BEFORE THE ENVIRONMENTAL QUALITY COUNCIL
STATE OF WYOMING

IN THE MATTER OF:)
BASIN ELECTRICAL POWER COOPERATIVE)
DRY FORK STATION,) Docket No. 07-2801
AIR PERMIT CT-4631)

**RESPONDENT DEPARTMENT OF ENVIRONMENTAL QUALITY'S
MEMORANDUM IN SUPPORT OF MOTION FOR PARTIAL SUMMARY
JUDGMENT**

Permit No. CT-3030

FIGURE 1

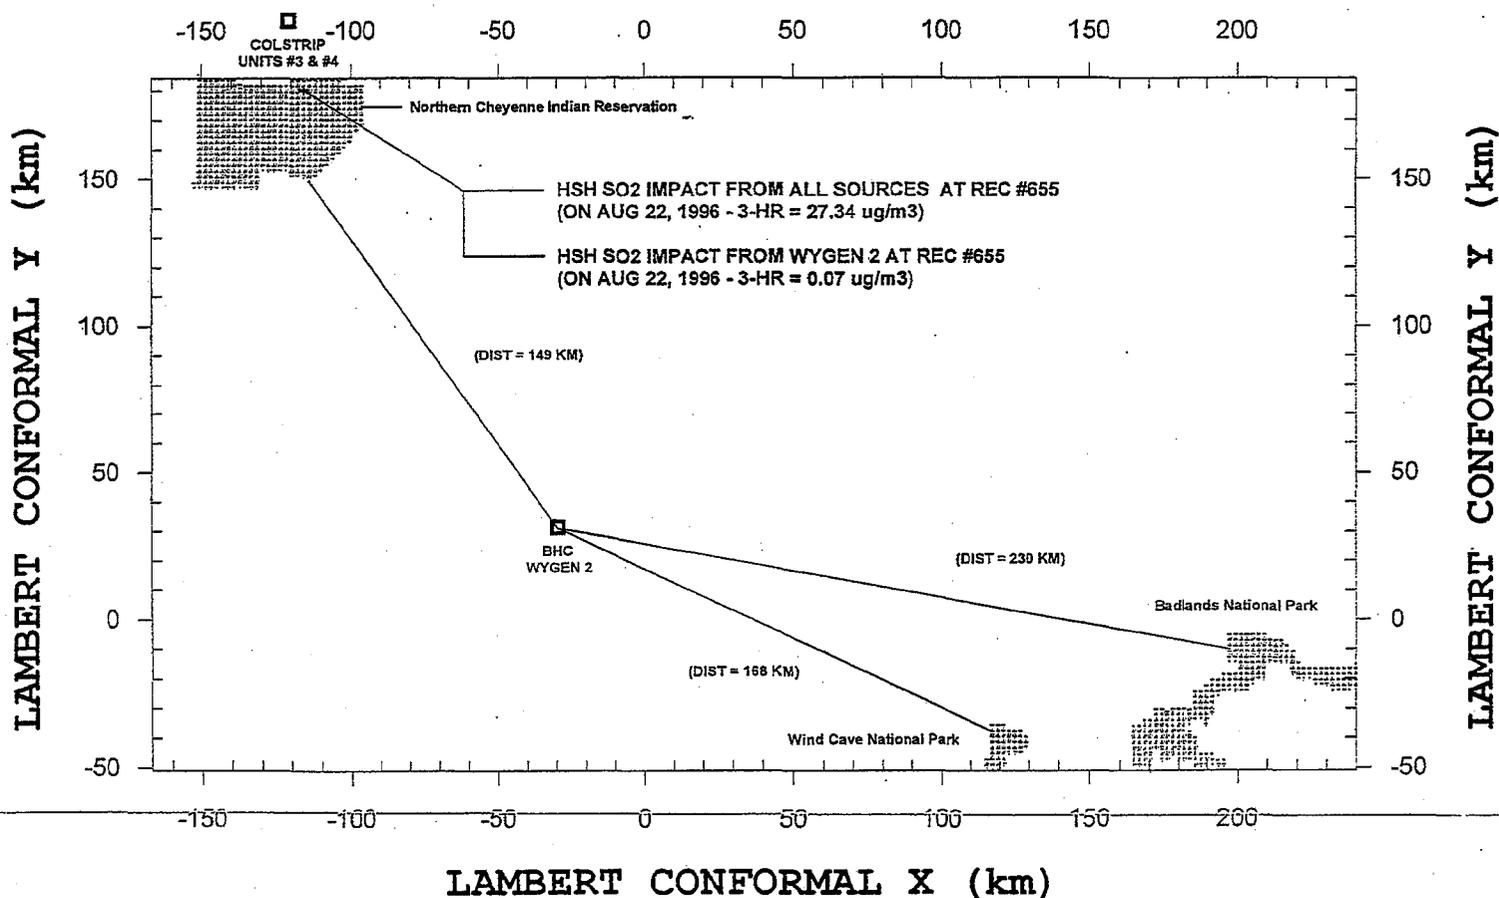
Response - Based on comments received during the public comment period, the applicant conducted an additional cumulative Class I SO₂ increment consumption analysis and included the Colstrip power plant (Unit #3 & Unit #4). The two sources at the Colstrip facility were modeled using the allowable 3-hour and 24-hour emission rates to compare with the Class I 3-hour and 24-hour increments, respectively.

The applicant attempted to utilize a newly developed CALMET wind field created for the Division, but was unable to run all months of the annual CALMET simulation, and could not turn on the chemistry and dry deposition algorithms in the model simulations. Since the Class I SO₂ increment analysis could be run without chemistry and dry deposition turned on in the CALPUFF simulations, it was decided by the Division that a Class I SO₂ increment analysis could be completed by the applicant using this wind field. On July 2, 2002, the applicant submitted a revised cumulative Class I increment consumption analysis using a 3-hour short-term SO₂ emission rate of 0.15 lb/MMBtu.

During the Division's review of this permit application, it was determined that the surface data file (surf.dat) used by the applicant in the CALPUFF modeling simulations contained invalid surface pressure data. The Division discovered invalid hourly surface pressure data at several surface stations in the Powder River Basin were affecting the chemistry and dry deposition options. A new surface meteorological data file was generated after removing the invalid pressure data, and the Division reran the applicant's modeling simulations using the revised surface meteorological data file. Based on the Division's Class I increment consumption analysis, the highest second highest (HSH) 3-hour SO₂ impact was 27.3 µg/m³ from all SO₂ sources represented in the Class I increment analysis, indicating a single modeled exceedance of the 3-hour SO₂ Class I increment level of 25 µg/m³ at the Northern Cheyenne Indian Reservation.
